AGENDA
DANIA BEACH CITY COMMISSION
REGULAR MEETING
TUESDAY, JANUARY 24, 2017 - 7:00 PM

A RESOLUTION OF THE CITY COMMISSION OF THE CITY OF DANIA BEACH, FLORIDA, APPROVING THE SITE PLAN (SP-18-16) SUBMITTED BY BIAGI CONSULTING ENGINEERS ON BEHALF OF THE PROPERTY OWNER, ALEX NICHOLS, FOR PROPERTY LOCATED AT 3001 SOUTHWEST 26 TERRACE IN THE CITY OF DANIA BEACH, FLORIDA, AS LEGALLY DESCRIBED IN EXHIBIT “A,” A COPY OF WHICH IS ATTACHED TO THIS RESOLUTION; PROVIDING FOR CONFLICTS; FURTHER, PROVIDING FOR AN EFFECTIVE DATE.

A RESOLUTION OF THE CITY COMMISSION OF THE CITY OF DANIA BEACH, FLORIDA, APPROVING THE SITE PLAN (SP-52-16), SUBMITTED BY DUNAY, MISKEL & BACKMAN, LLP ON BEHALF OF THE OWNER, CALM PROPERTIES, LLC, FOR PROPERTY LOCATED AT 601 EAST DANIA BEACH BOULEVARD IN THE CITY OF DANIA BEACH, FLORIDA, AS LEGALLY DESCRIBED IN EXHIBIT “A,” A COPY OF WHICH IS ATTACHED TO THIS RESOLUTION; PROVIDING FOR CONFLICTS; FURTHER, PROVIDING FOR AN EFFECTIVE DATE. *(Continued from January 10, 2017)*

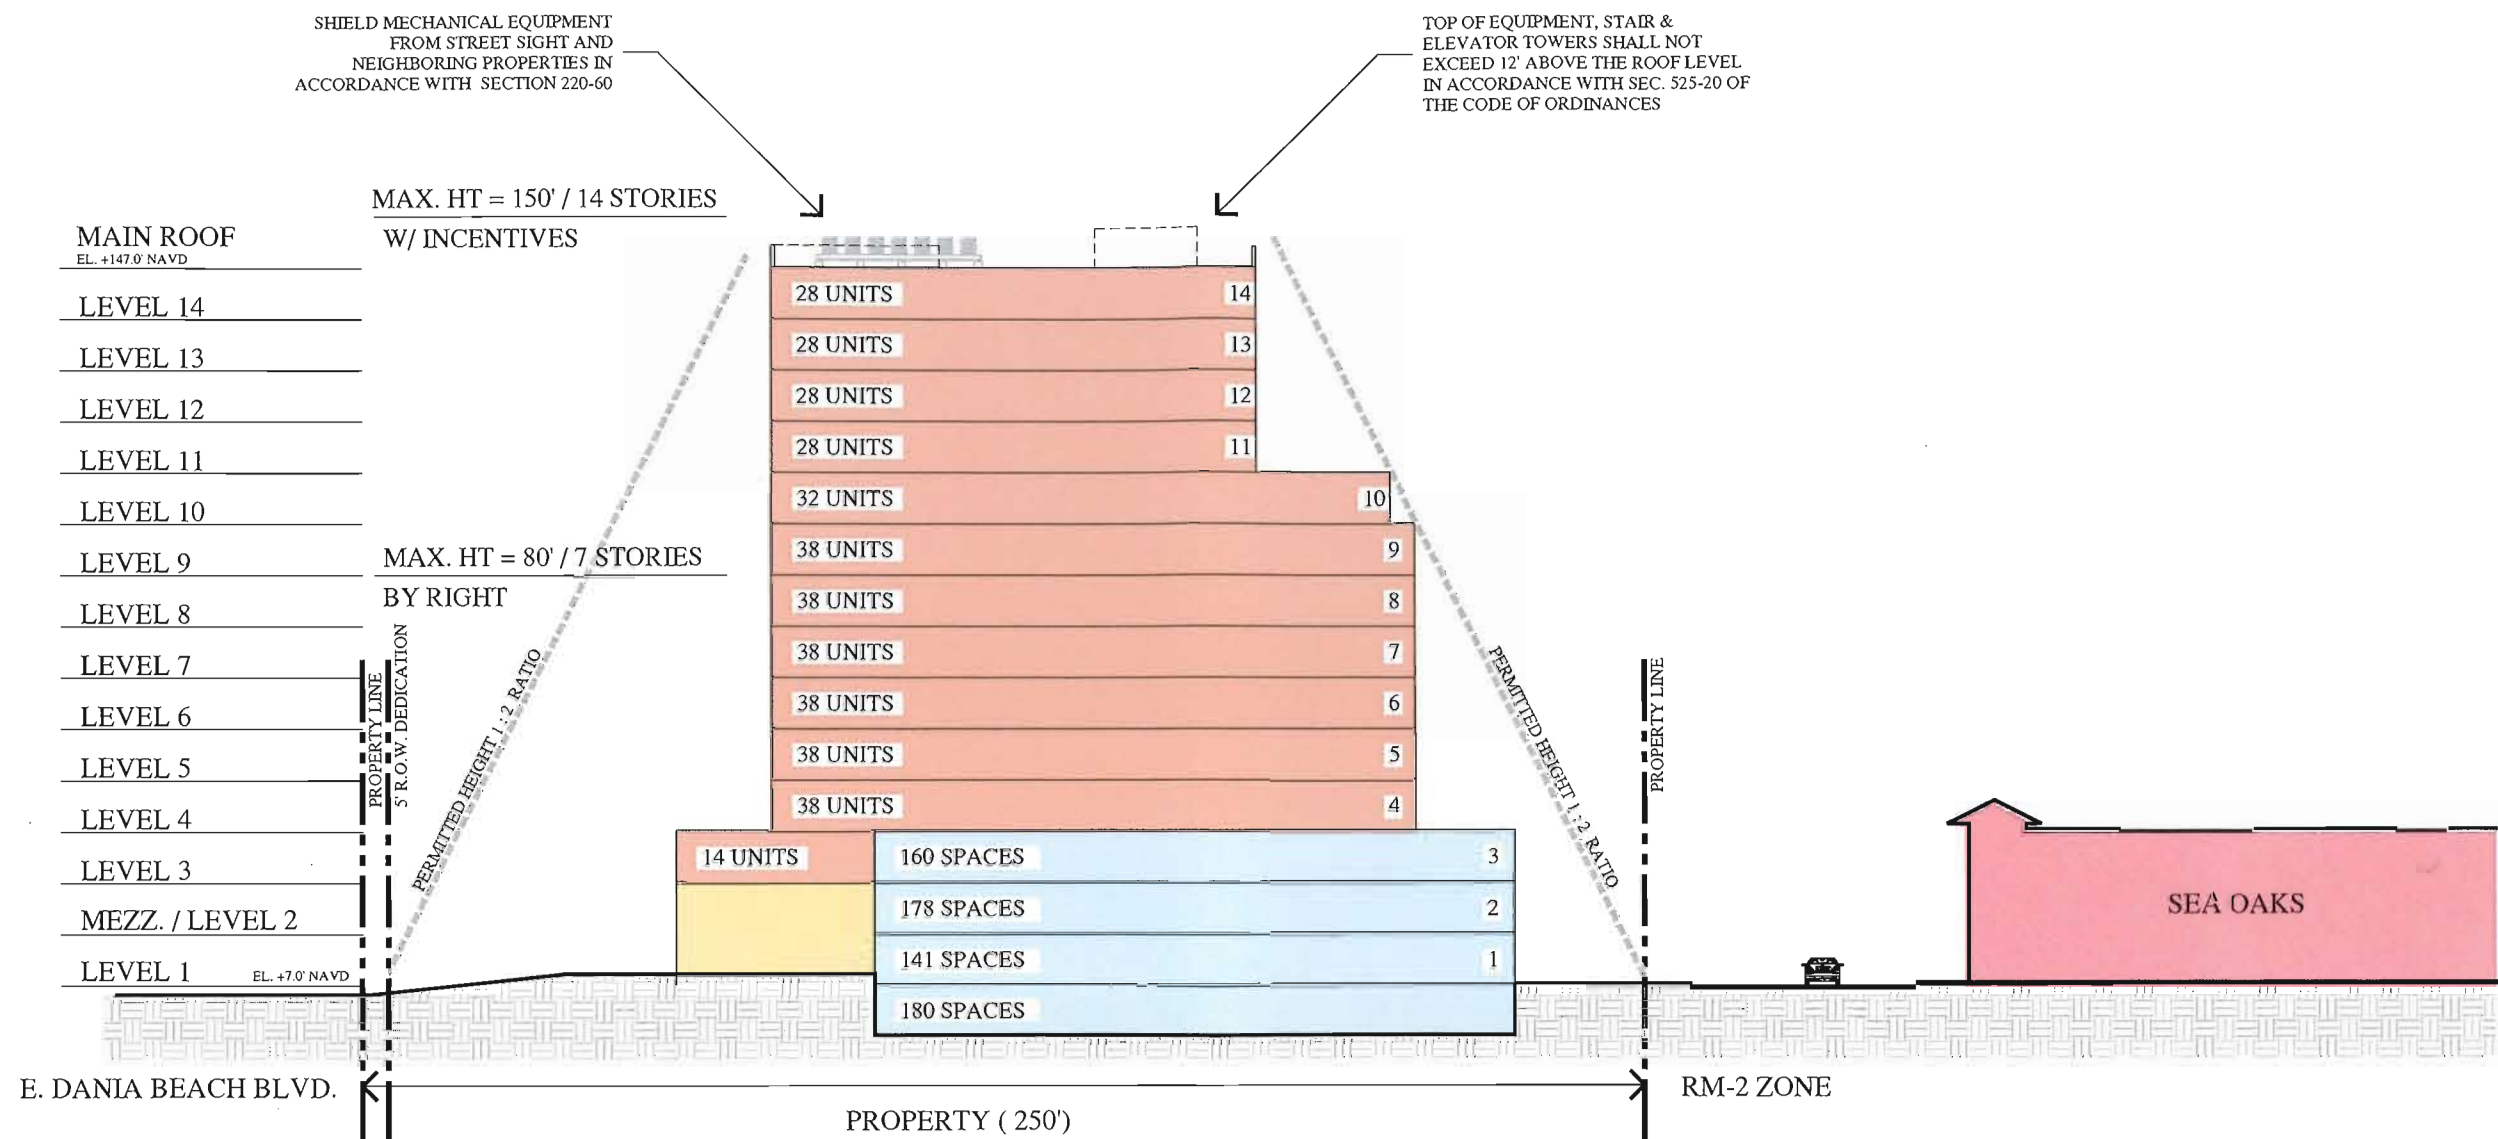
3. The building step back (1:2 slope) will need to be adjusted based on the proposed Right-of-Way dedications as it is to be measured at the property line. On sheet A-2, the eastern elevation shows the front setback at 47', however, is is closer to 30' based on the Right-of-way dedications (due to the turnlane/bikelane). Once the setback is adjusted, the step back line (1:2) will encroach into the eastern tower.

3. The minimum height for fire rescue apparatus access is 14', however, all floors in the parking structure are still shown only 10' high (sheet A-2). How will the Fire Department be able to access the parking structure?
